**PLANNING DIRECTOR'S SPECIAL PERMIT
FOR SINGLE FAMILY RESIDENTIAL IN A PUD**

FILE: P99-150

PROJECT NAME: Castle Collection in Natomas Crossing - Villages 16 & 17

Exhibit 8(a) - Plan 2367, elevations

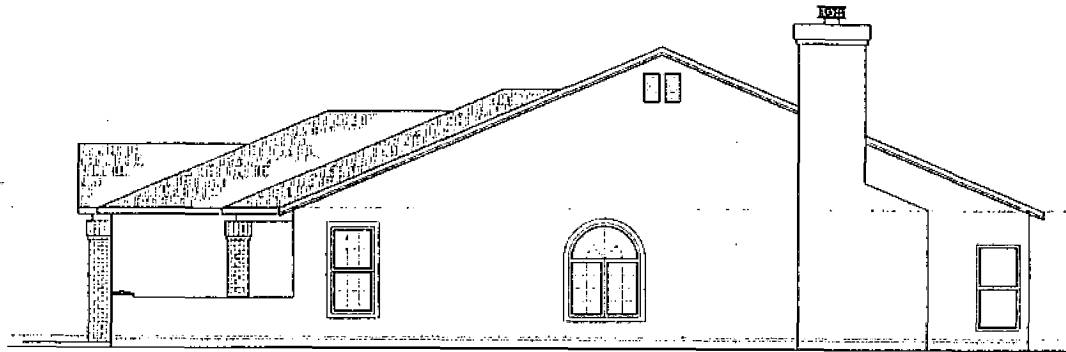
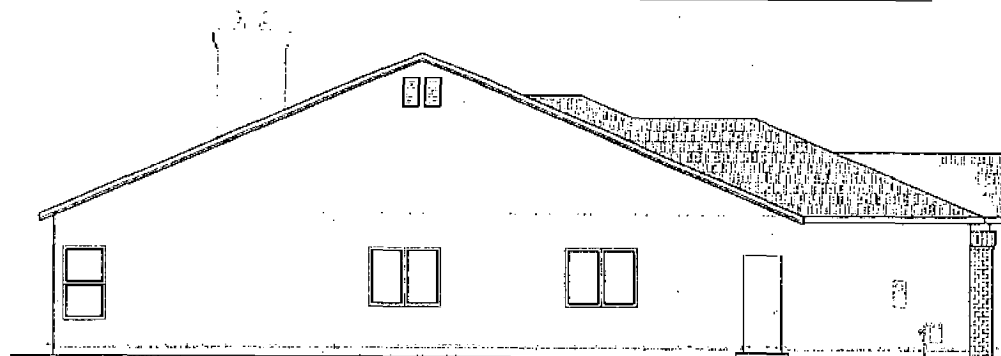
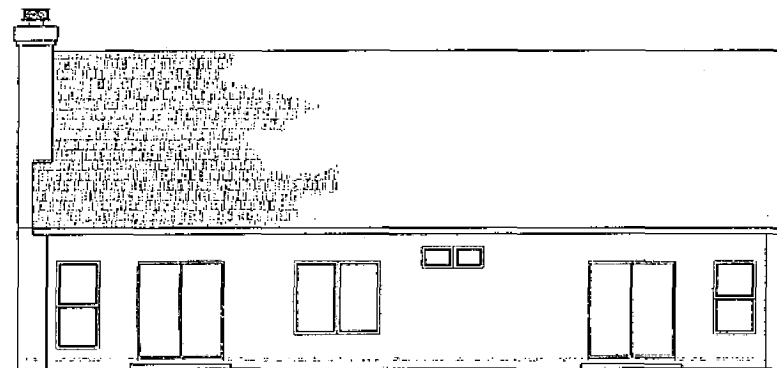
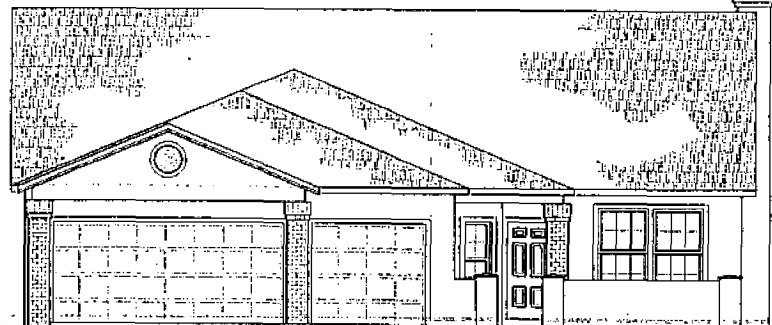
- b. The front courtyard feature shall be required on the 2367 (Windsor) plan, as shown on the attached Exhibit 8 (a-d);
 - c. The 2367 (Windsor) plan may be placed on only ten of the lots identified in Exhibit 3, since this plan will exceed 45 percent lot coverage on these lots; the PUD Guidelines allows up to ten percent of lots in the subdivision to exceed 45 percent lot coverage up to 48 percent;

Exhibit 9(a) - Plan 2634, elevations

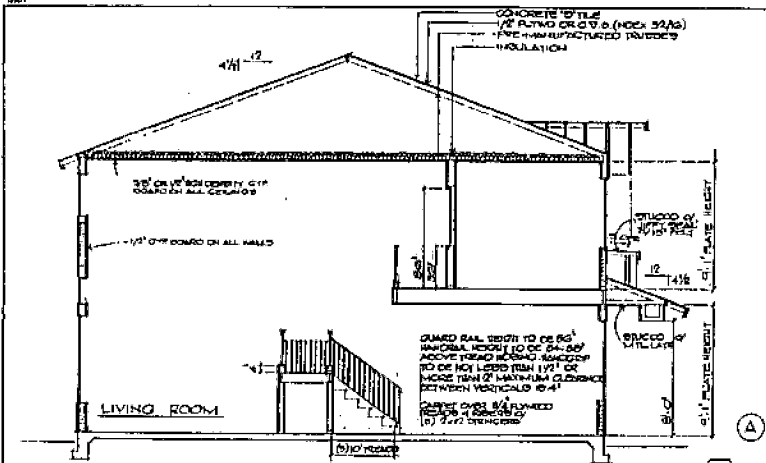
Roof pitch was not indicated on any of the submitted plans but the 2634 (Leeds); and on that plan, roof pitch is specified at 4½:12. The amended Natomas Crossing PUD Guidelines do not specify a minimum roof pitch, though other North Natomas PUDs generally require a minimum of 5:12 with provision for approval of some variance from that minimum for a specific architectural effect. The 4½:12 roof pitch shown on the plans submitted appears to be appropriate for the architectural design of these plans and staff recommends approval with that minimum.

- e. Any proposal to locate the 2634 (Leeds) plan, which features the side entry garage, on a corner lot will be subject to additional review and approval by the Planning Director, including submittal of a plot plan to Planning Staff illustrating the proposal in detail;

- k. Roof pitch shall be no less than a 4½ to 12 pitch.
